BUREAU OF INDIAN STANDARDS

DRAFT FOR COMMENTS ONLY
(Not to be reproduced without permission of BIS or used as an Indian Standard)

DRAFT AMENDMENT NO. 1 TO IS 18606: 2024 ELECTRIC POWER TRAIN OF M AND N CATEGORY VEHICLES — SPECIFIC REQUIREMENTS

Electric and Hybrid Vehicles Sectional Committee, TED 27

FIG. 7 MEASUREMENT OF U2'

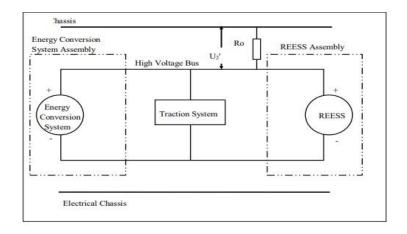
(Page 24, Clause Fig. 7) — Substitute the following for the existing:
